APPLICATION NO.	FILING DATE	FIRST NAMED INVENTOR	ATTORNEY DOCKET NO.	CONFIRMATION NO.
10/643,447	08/19/2003	Jerome A. Cohen	6842-0001-1	4405

Office Action Summary

PATENT COPY W/ANNOTATIONS

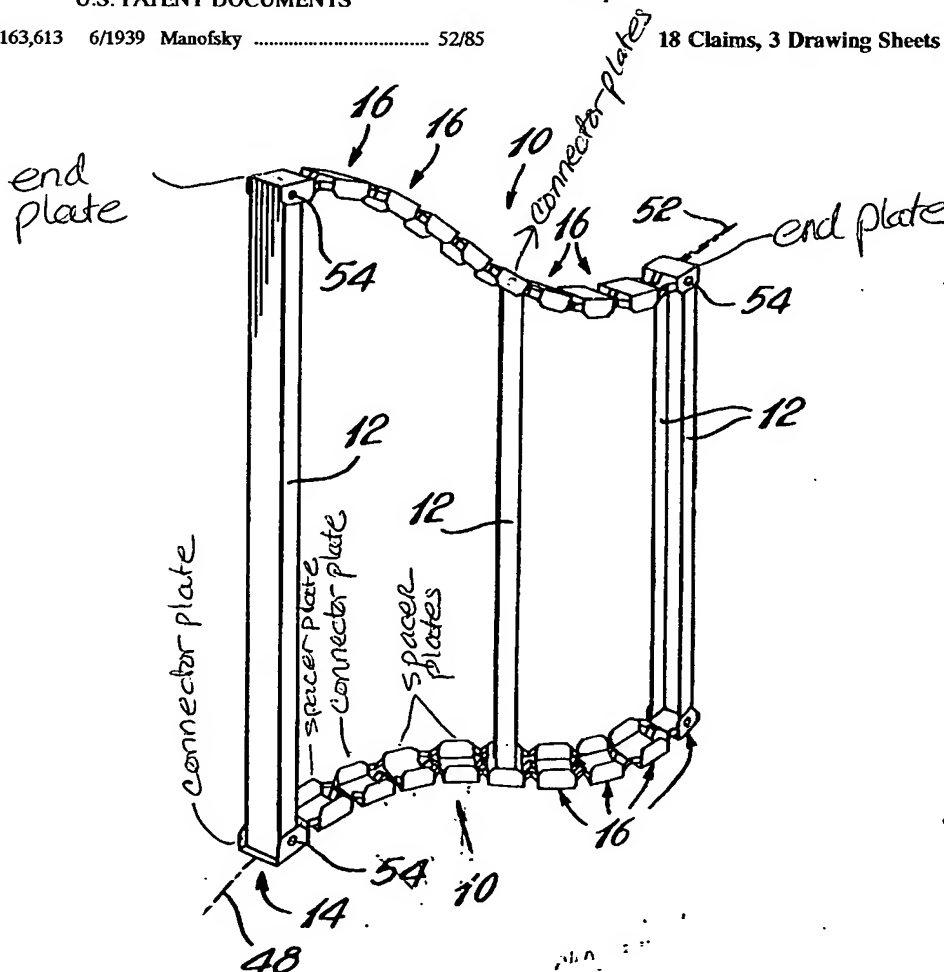
- A plurality of connector plates 16 each including retaining means for receiving an end of a structural member 12;
- A plurality of spacer plates 16; see annotations on patent copy;

The last connector plate on each opposite end has been considered as the end plates. See annotations on patent copy. See 35 USC 112 rejection above. For the other recited elements see 35 USC 102 rejection above.
